**GW - 001**

**GENERAL  
CORRESPONDENCE**

A WORK PLAN FOR  
MONITORING, TESTING, ANALYSIS,  
AND REPORTING AT THE  
BLOOMFIELD REFINERY

**FIGURE 2.1**  
**ELEVATIONS OF THE TOP**  
**OF THE NACIMIENTO**  
**FORMATION AND**  
**PROPOSED ELECTRICAL**  
**RESISTIVITY SURVEY LINES**

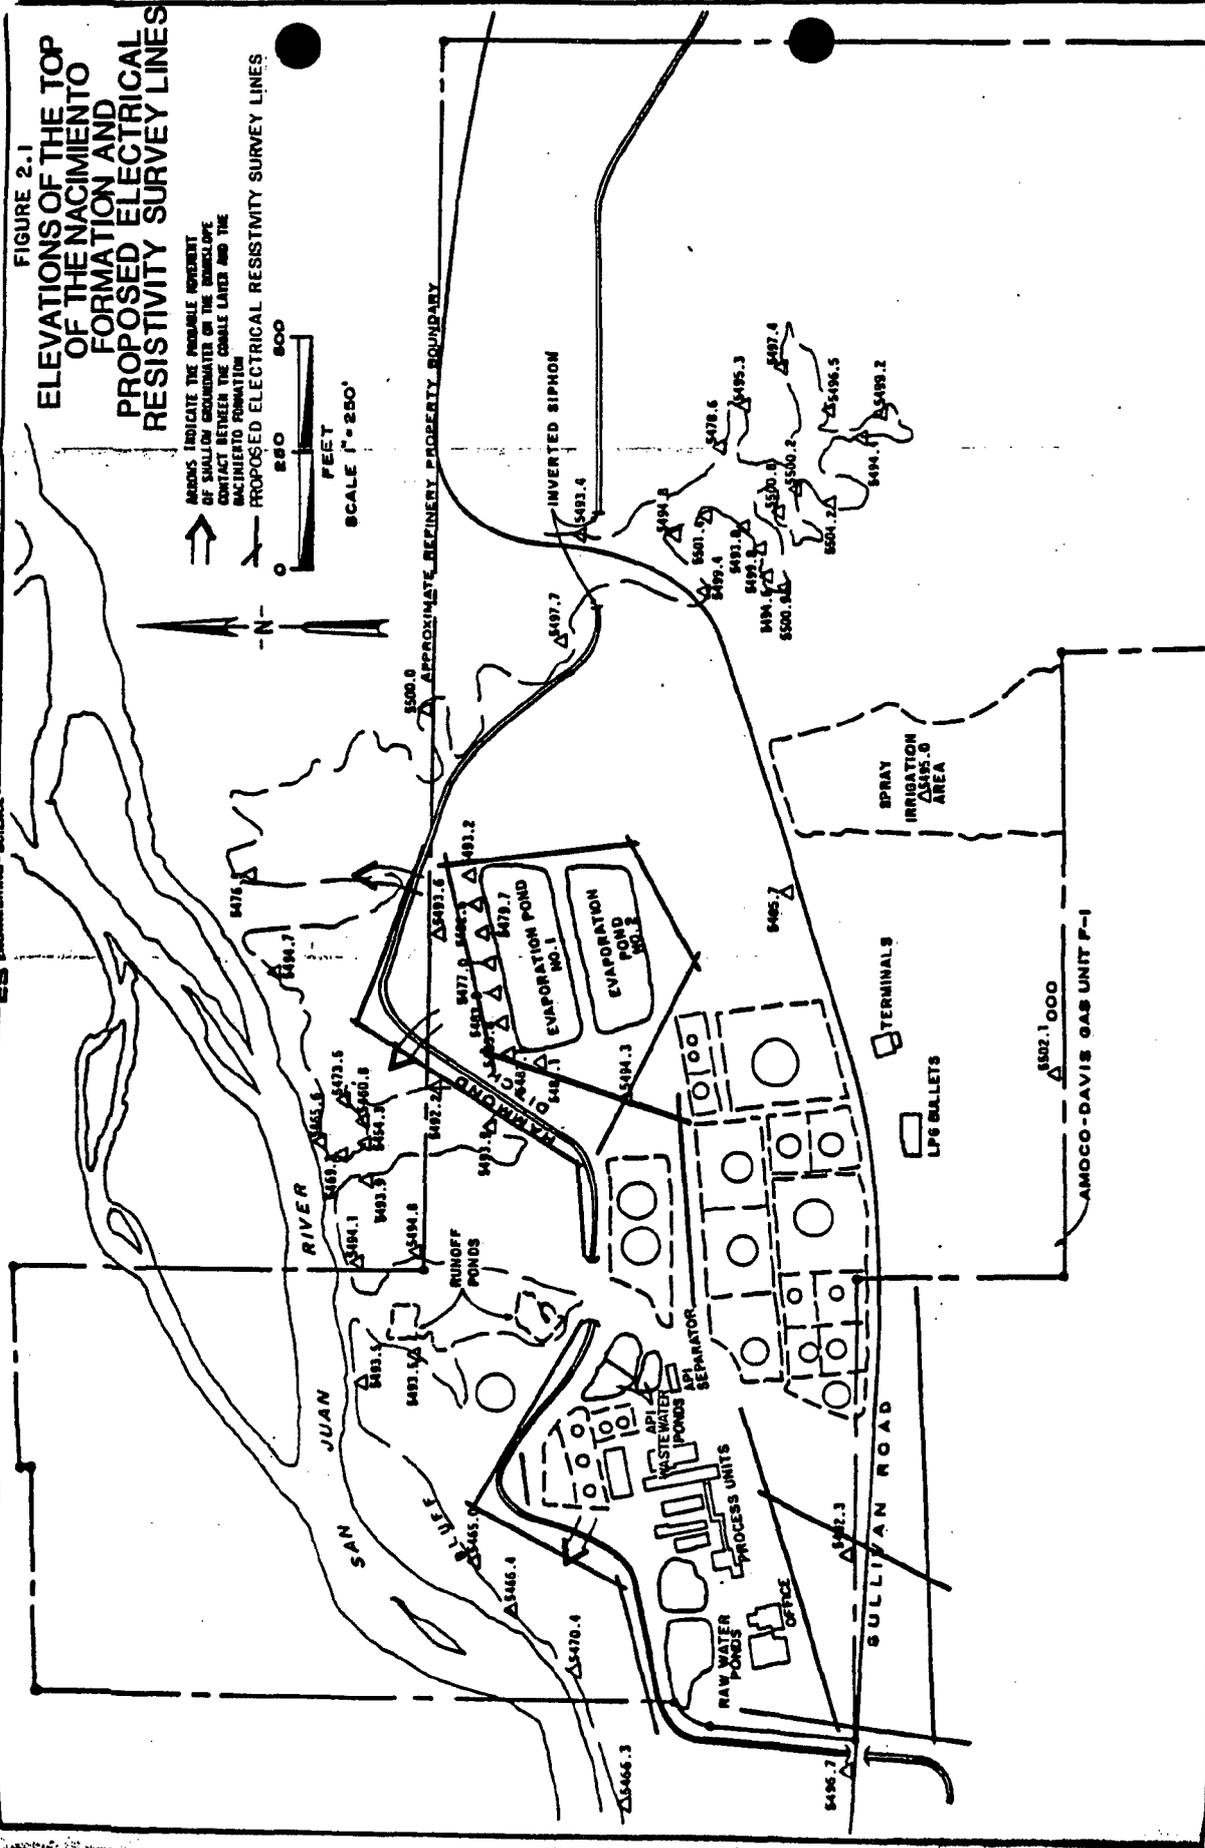
Approximate locations of the survey lines proposed for the electrical resistivity survey are shown on Figure 2.1. The resistivity survey data will be correlated with existing known elevations of the Nacimiento Formation near monitoring wells and boreholes prior to the examination of other areas, primarily between the Hammond Ditch and the San Juan River, in the

FIGURE 2.2  
LOCATIONS OF EXISTING AND PROPOSED MONITORING WELLS

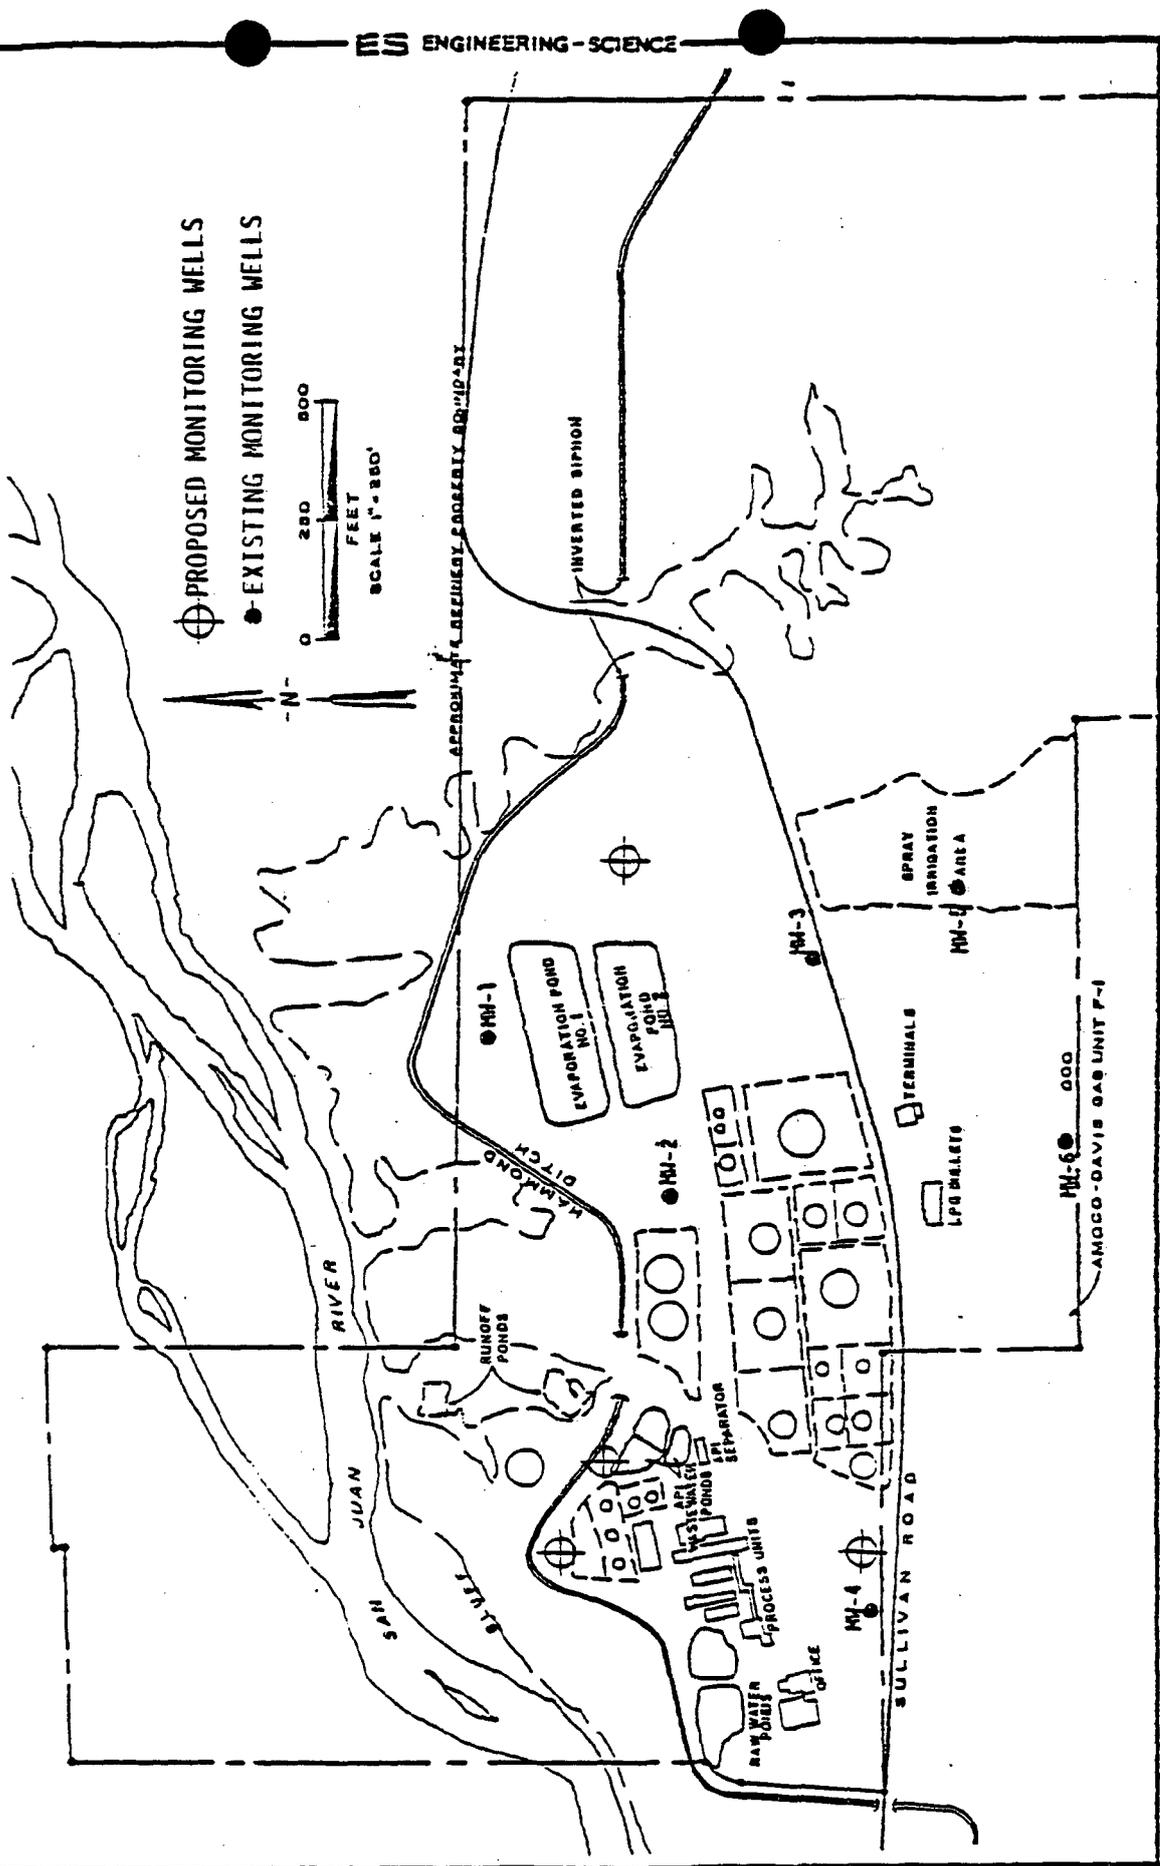
Four additional monitoring wells are proposed to provide information on the extent of petroleum hydrocarbons in the subsurface at the refinery. These proposed wells will be completed in the general areas shown on Figure 2.2.
